PD Modification Application: PRS 23-0381

BOCC Land Use Meeting Date: July 18, 2023

1.0 APPLICATION SUMMARY

2.5 Proposed Site Plan (partial provided below for size and orientation purposes. See Section 8.2 for full site plan)

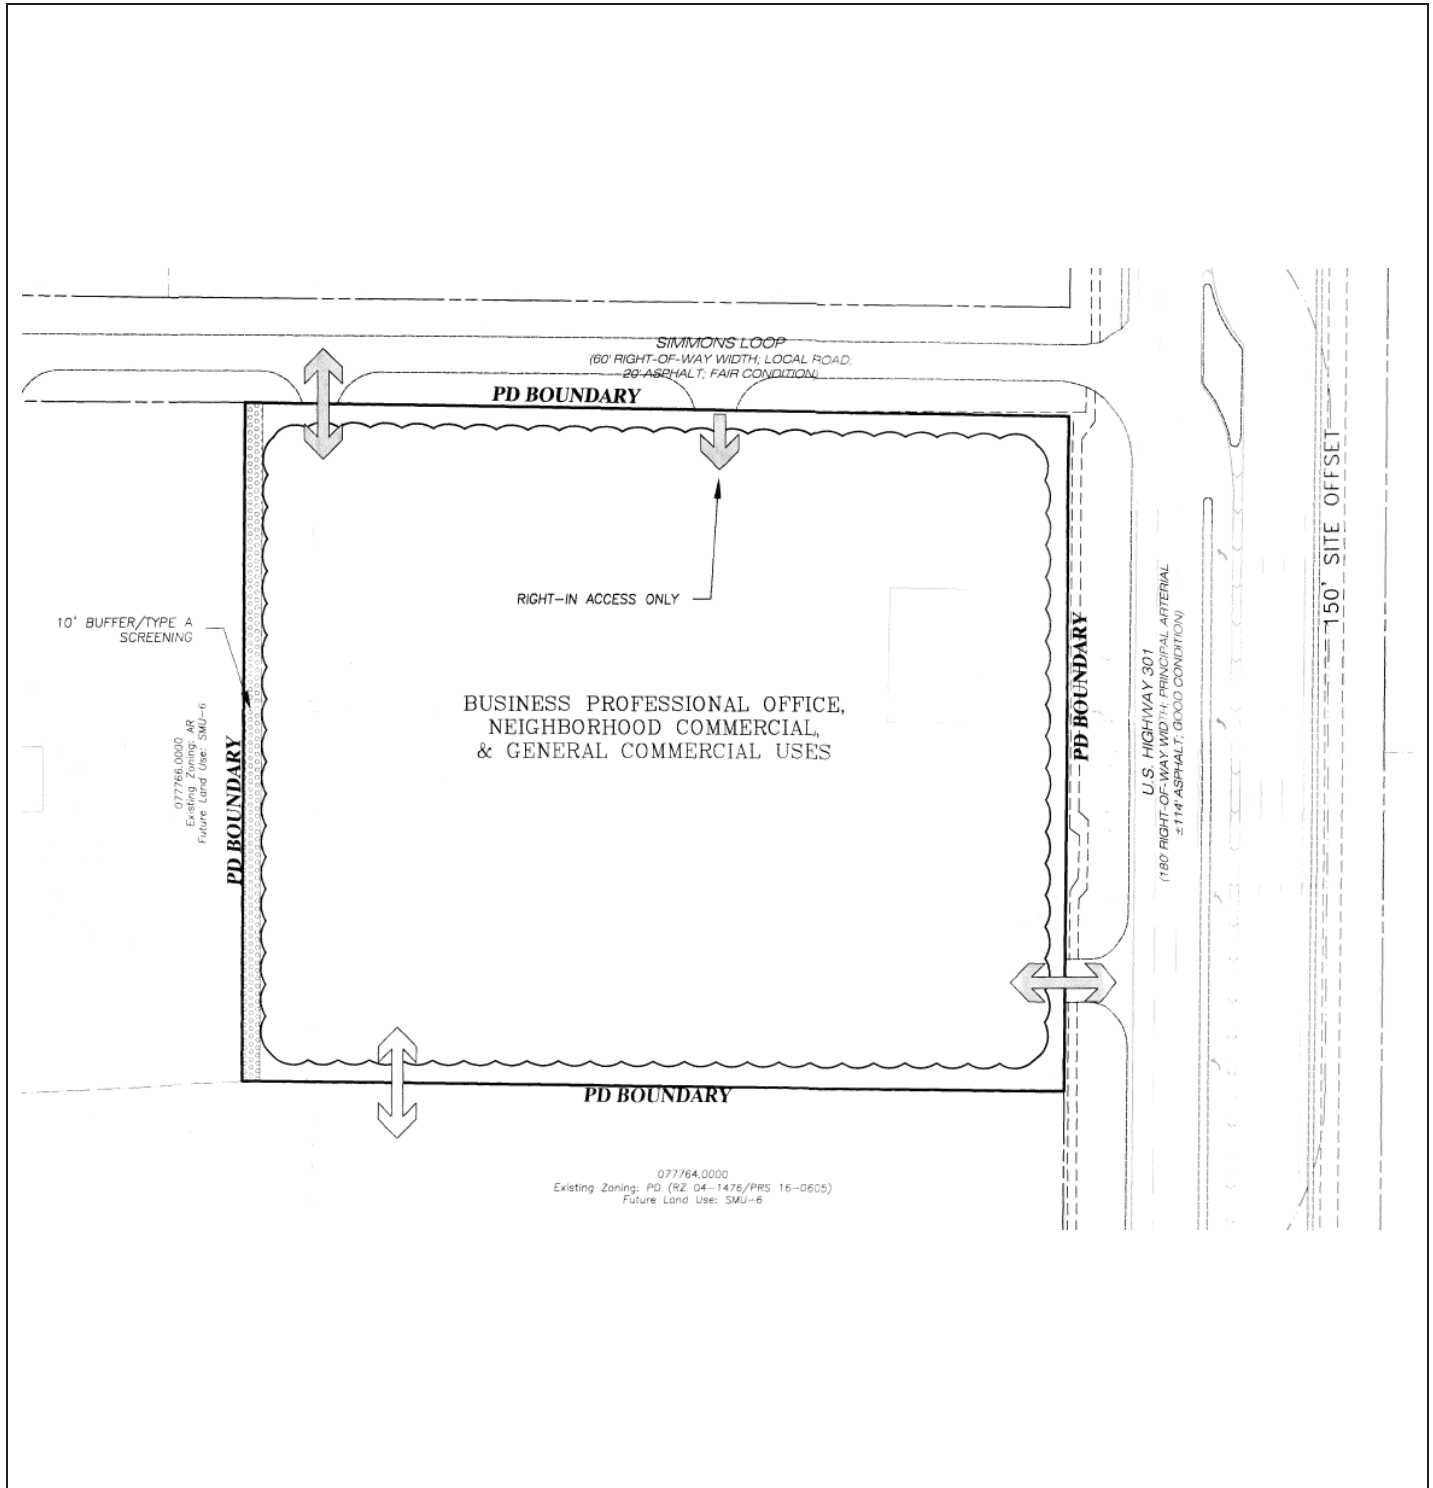
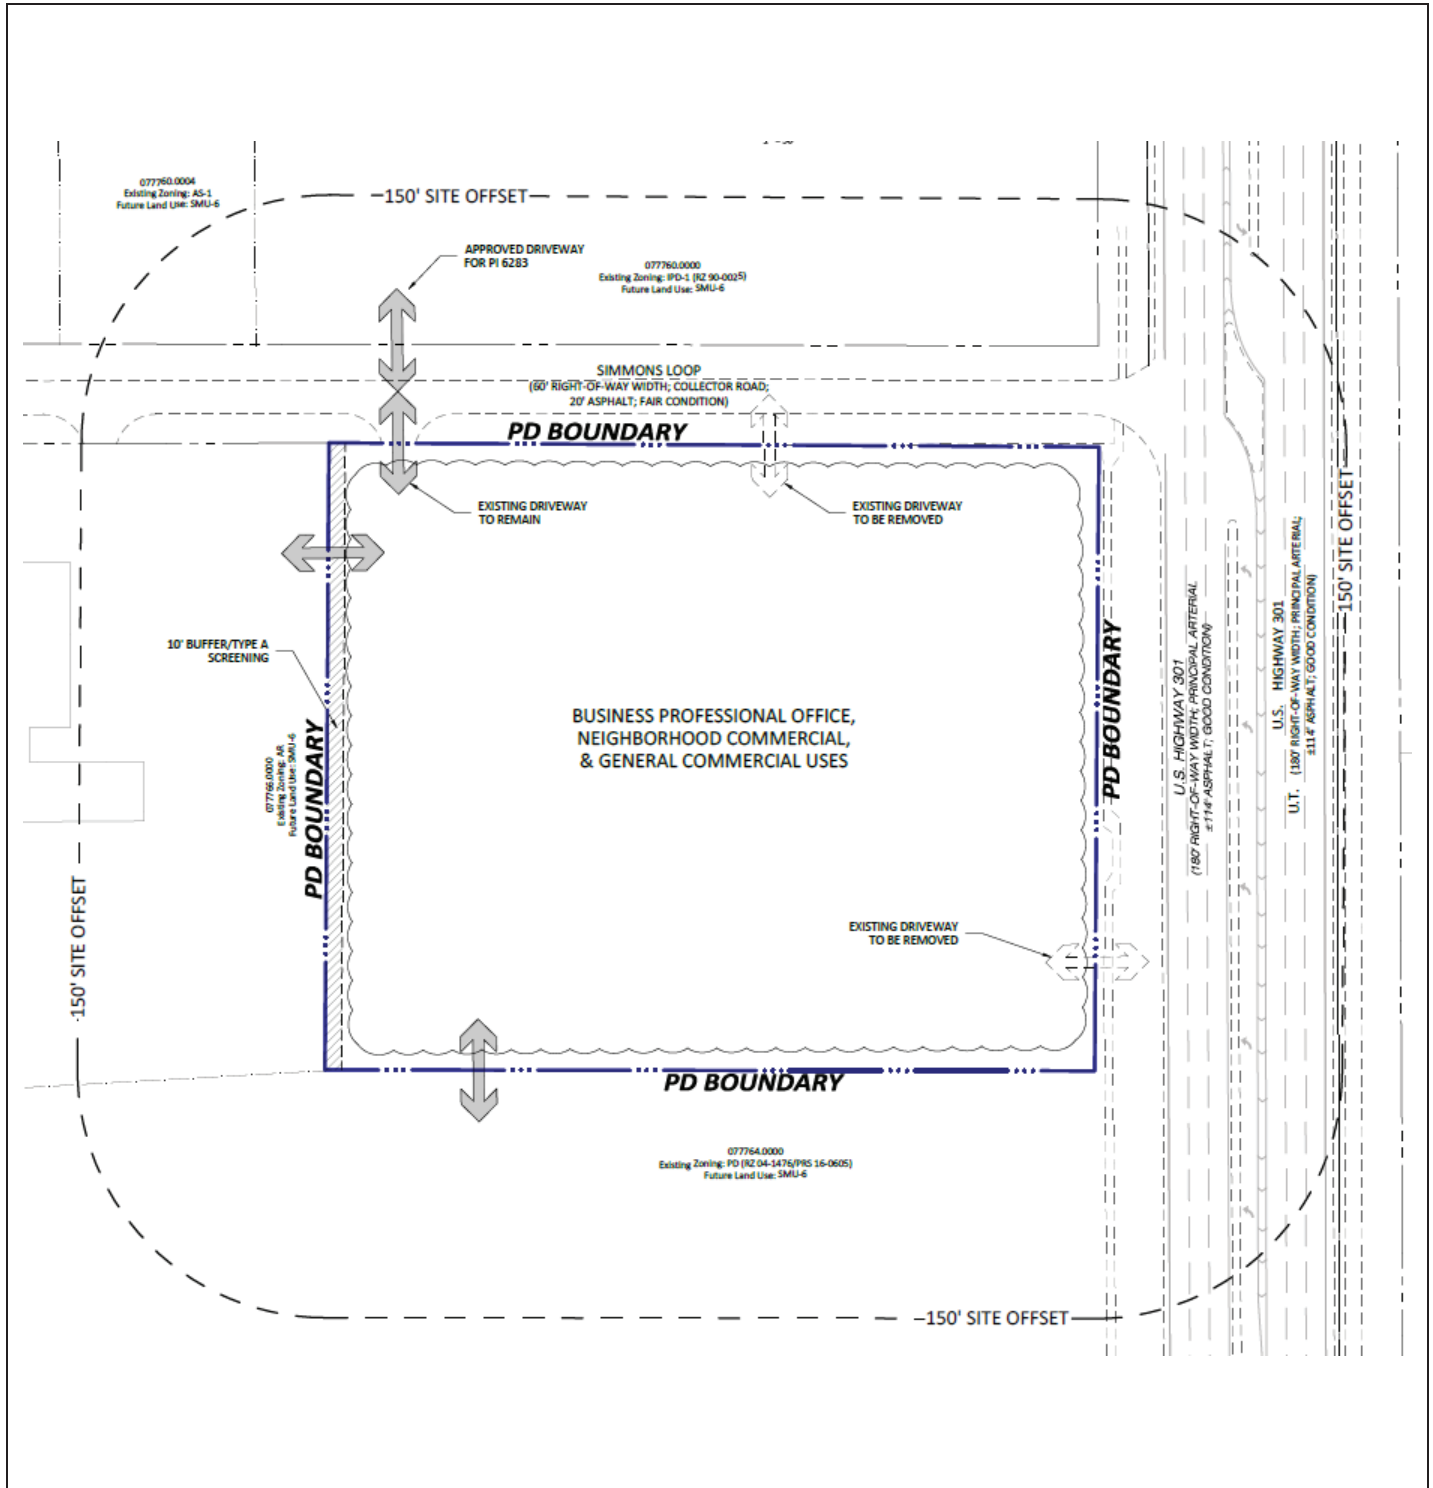
Existing Approval(s):	Proposed Modification(s):
Four access points: two on Simmons Loop, one on US Highway 301; and one to the southern property.	Remove the easternmost access on Simmons Road, and on US 301.

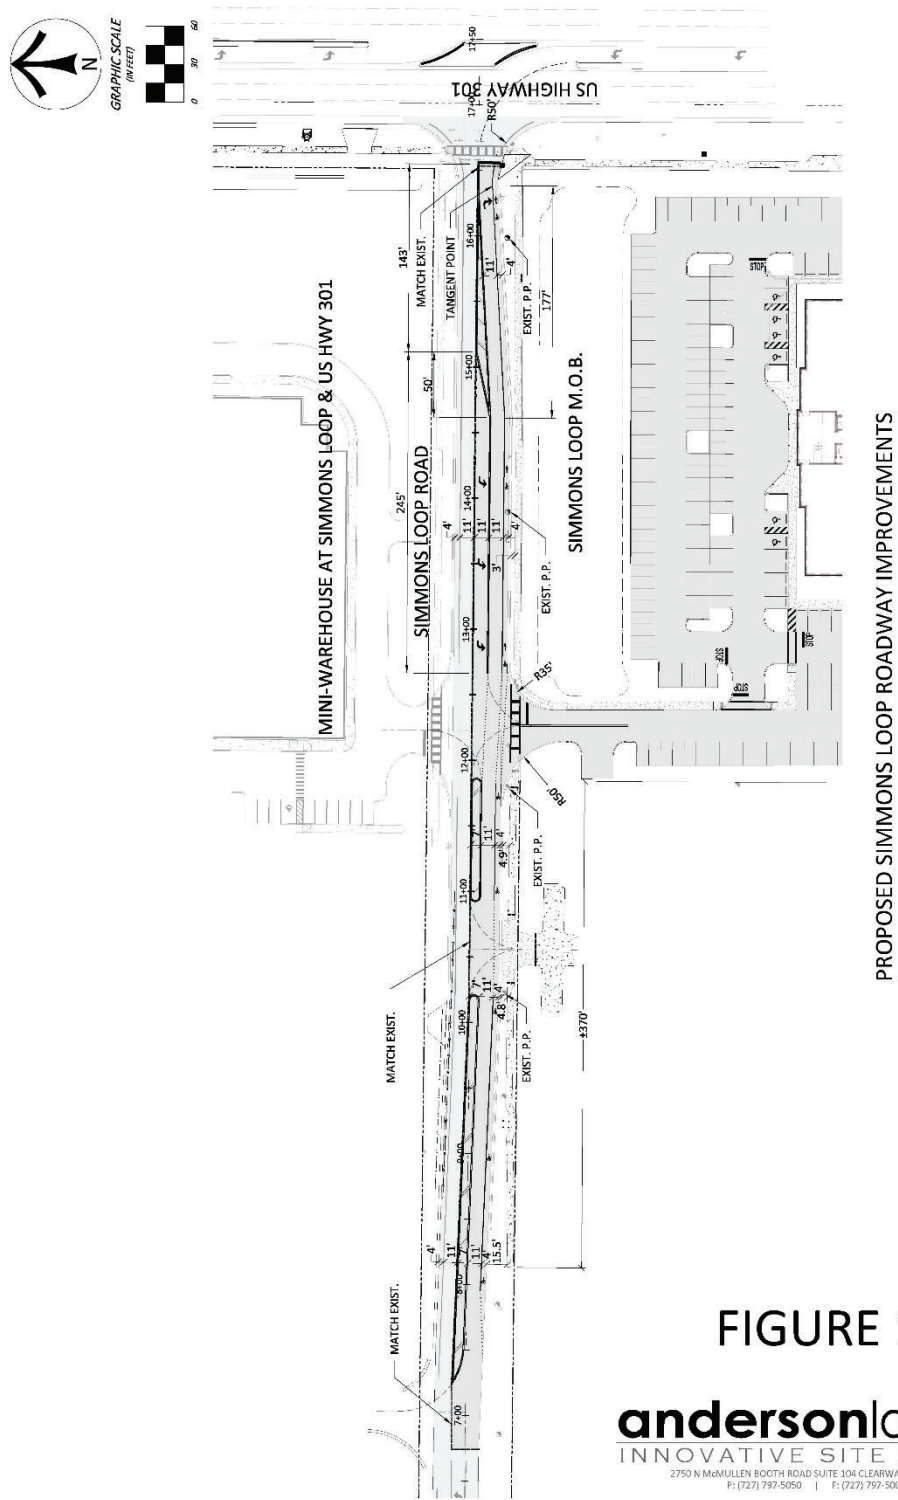
Based on the projected volumes, a westbound left turn lane is warranted at the project access on Simmons Loop. As shown on the attached Figure 1, the developer proposes to construct a 245 foot left turn lane. If any additional right of way and/or easement from the subject property is required to accommodate the improvements along Simmons Loop, they will be conveyed to the County as a part of the permitting process.

FIGURE 2
SIMMONS LOOP
TYPICAL SECTION

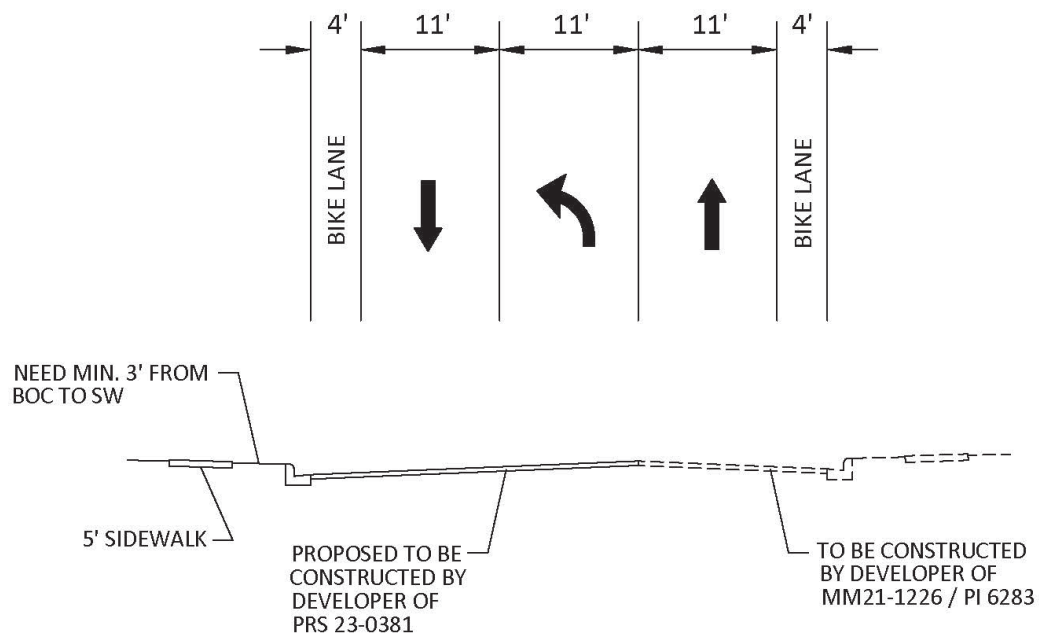
- 1) Bike Lanes – TS-4 has 7 foot buffered bike lanes. Due to right of way constraints and to be consistent with the other sections of Simmons Loop, the developer proposes to provide 4 foot bike lanes.

Figure 1 illustrates the proposed improvements along Simmons Loop for the project. Figure 2 provides the typical section from US 301 to the project access and Figure 3 provides the typical section west of the project access with the transition along Simmons Loop.

- 1) Bike Lanes - TS-4 requires 7-foot buffered bike lanes. Due to right of way constraints, the developer proposes to provide a 4-foot bike lanes on the south side.
- 2) Bike Lanes - The developer must extend the 4-foot bike lane on the southside of Simmons Loop approximately +/- 370 feet west of the proposed access.

FIGURE 3
SIMMONS LOOP
TYPICAL SECTION

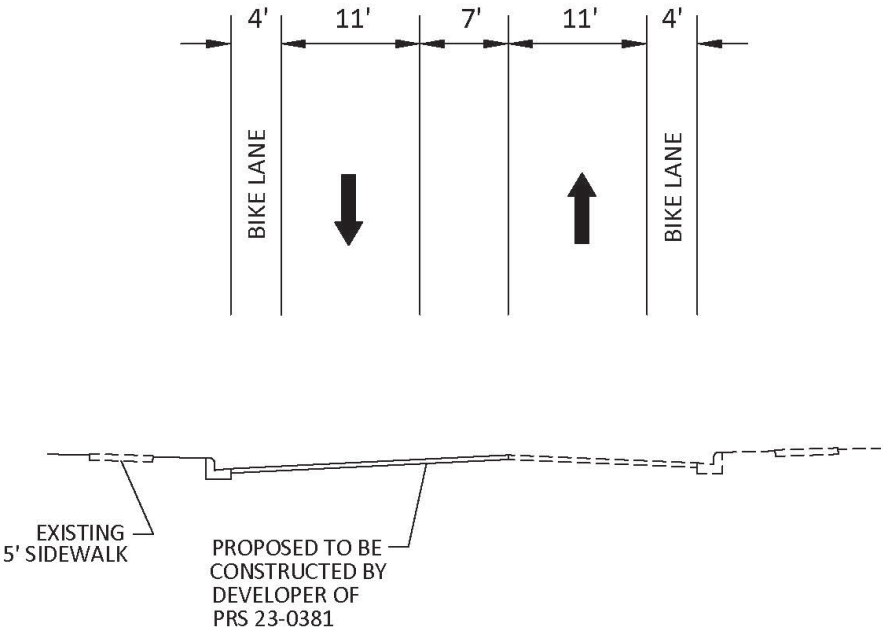
1. The proposed section will match the surrounding and will match the proposed roadway improvements per the plans for PI 6283.
2. The project has limited frontage and the right of way west of the project access is limited.
3. The developer is extending the 4 foot bike lane on the southside of Simmons Loop approximately 370 feet west of the proposed access.
